## SOILS AND GEOLOGY STUDY

**Lots 1-224, Paint Brush Hills, Filing No. 14  
El Paso County, Colorado**

**JOB NO. 179012**

SHEET No.  
**FIG-14**

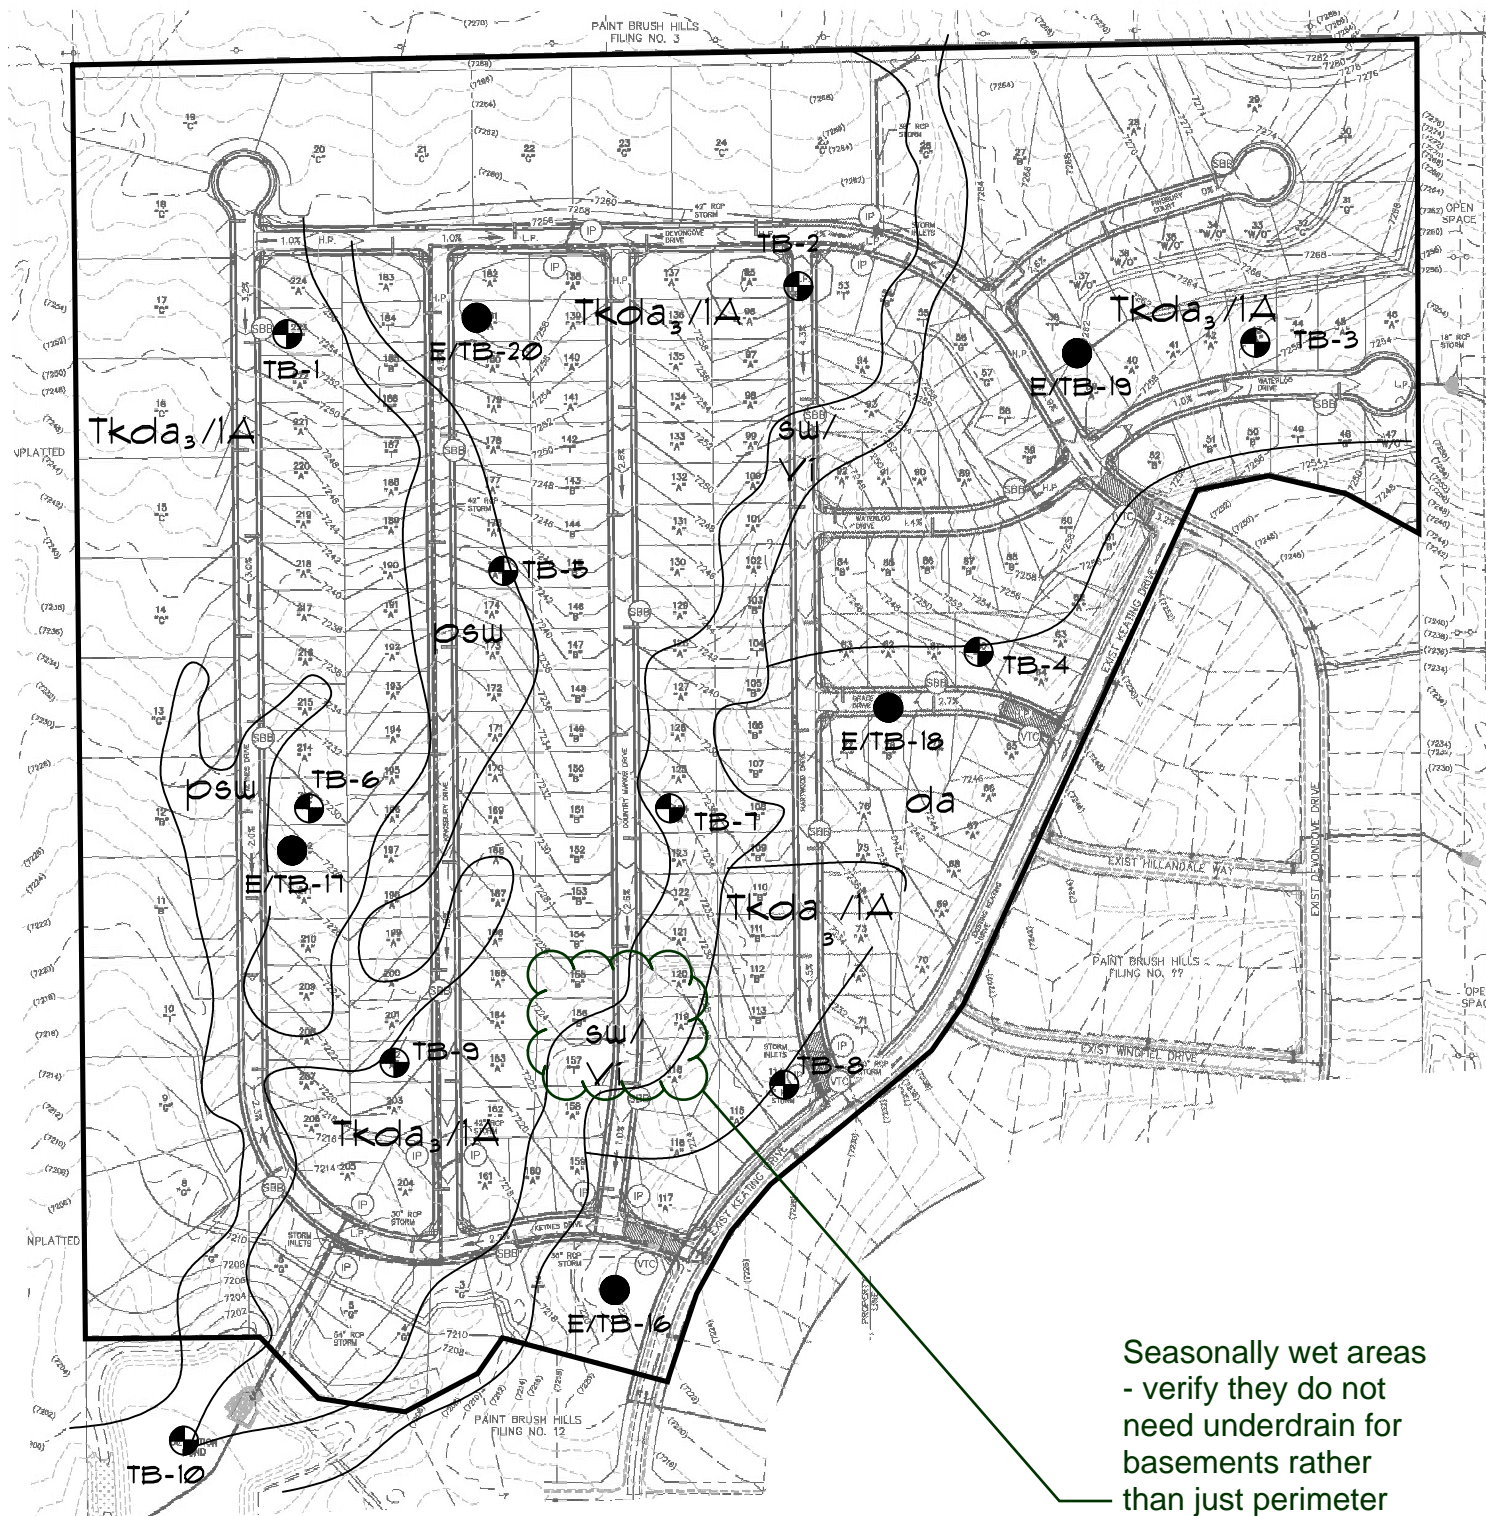
Seasonally wet areas - verify they do not need underdrain for basements rather than just perimeter drain. Alternatively basements can be prohibited on affected lots.
